CITY OF MANTECA

SUBJECT: TUP-21-83 DR HORTON NORTH MAIN COMMONS SALES OFFICE

The City of Manteca Planning Division has reviewed your Temporary Use Permit application for a sales office. Your project application has been approved with the following conditions:

Construction Details

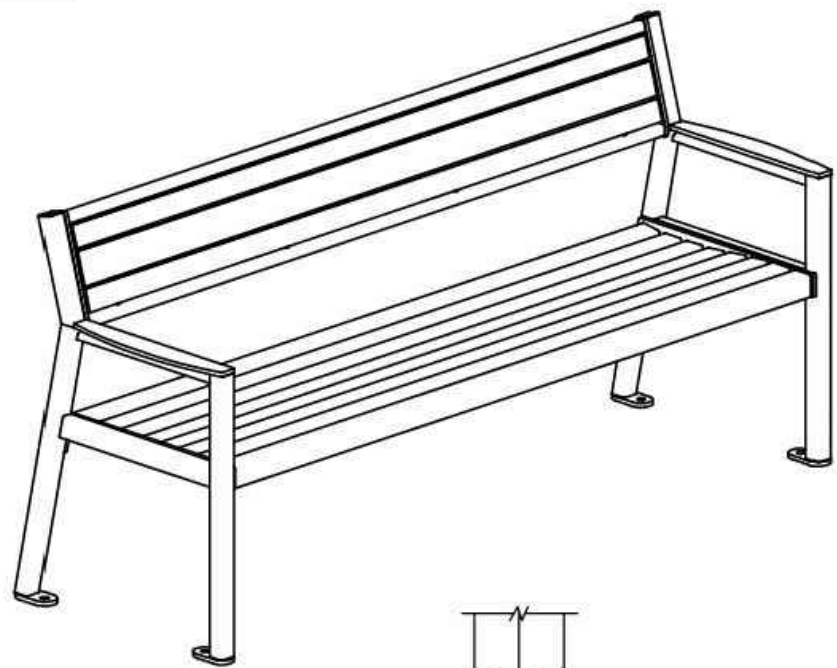
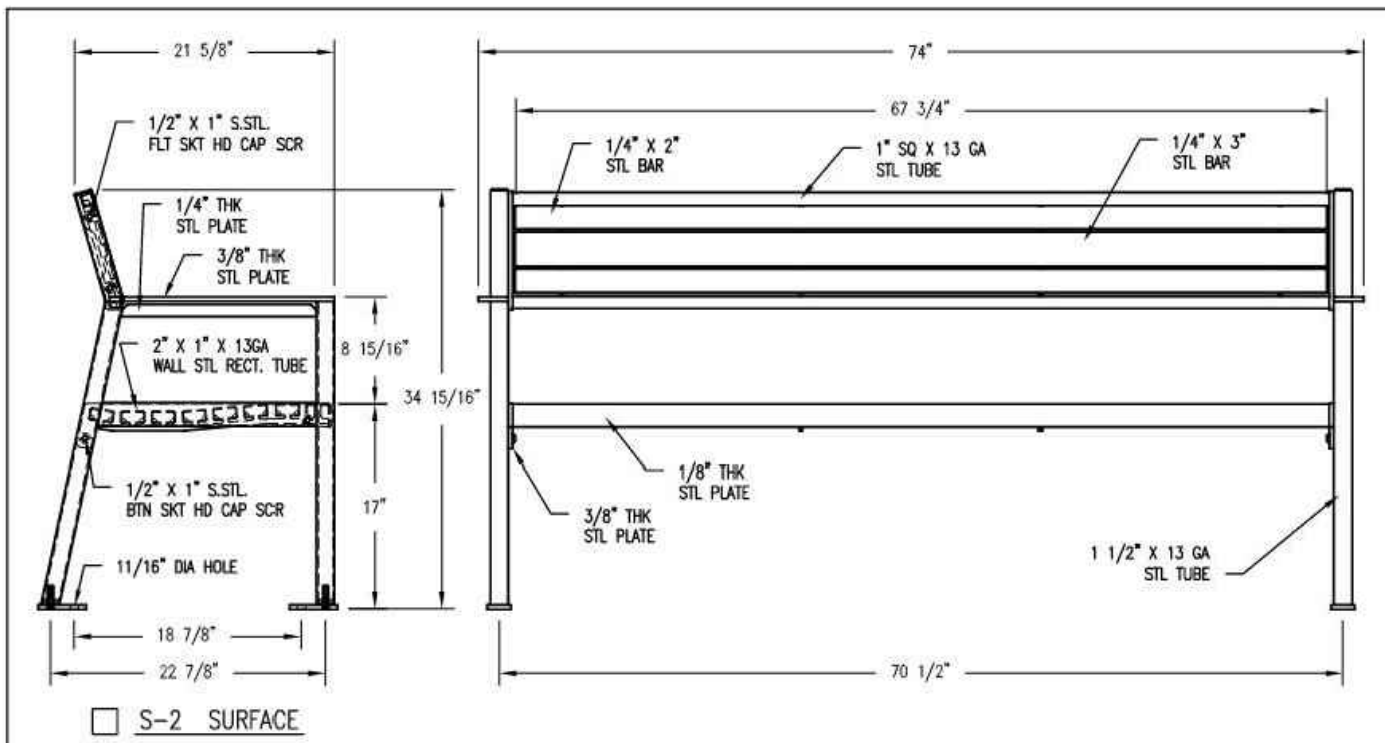
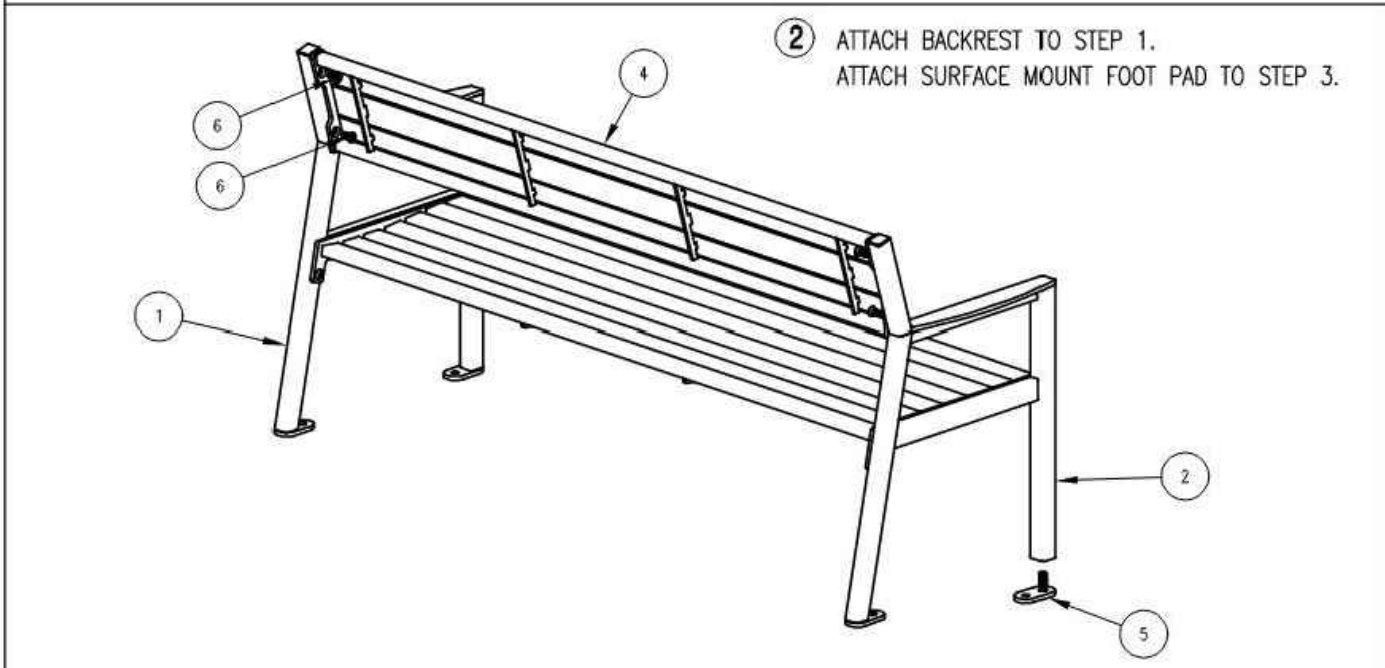
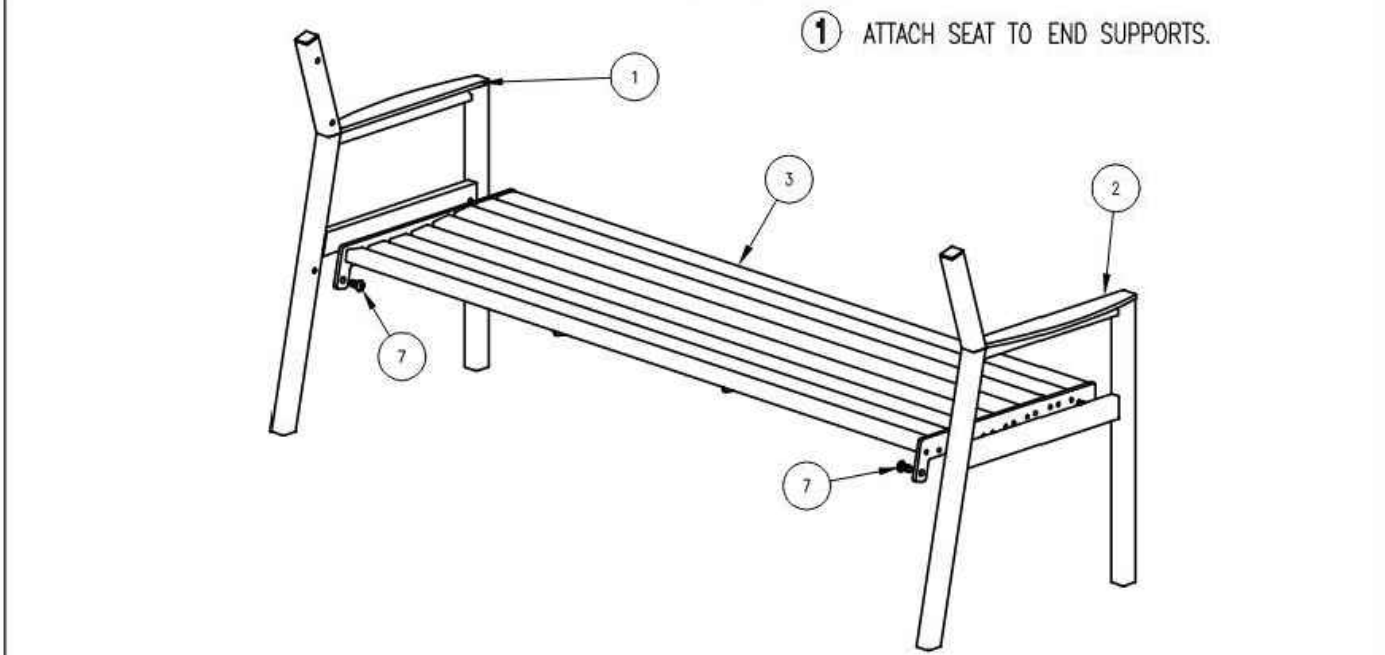
- Exception: Van parking spaces shall be permitted to be 108 inches (9') wide minimum where the access aisle is 96 inches (8') wide minimum.
14. Complete the information for the tow-away sign as follows: (Detail E/L2.1)

- "Unauthorized" vehicles parked in designated accessible spaces not displaying distinguishing placards or special license plates issued for persons with disabilities will be towed away at the owner's expense. Towed vehicles may be reclaimed at: **City of Manteca Police Department** or by telephoning **(209) 456-8101**."

15. Parking space identification signs shall be 60" minimum above the finish floor or ground surface measured to the bottom of the sign. Signs located within a circulation path shall be a minimum of 80 inches above the finish floor or ground surface measured to the bottom of the sign. (Detail E/L2.1).
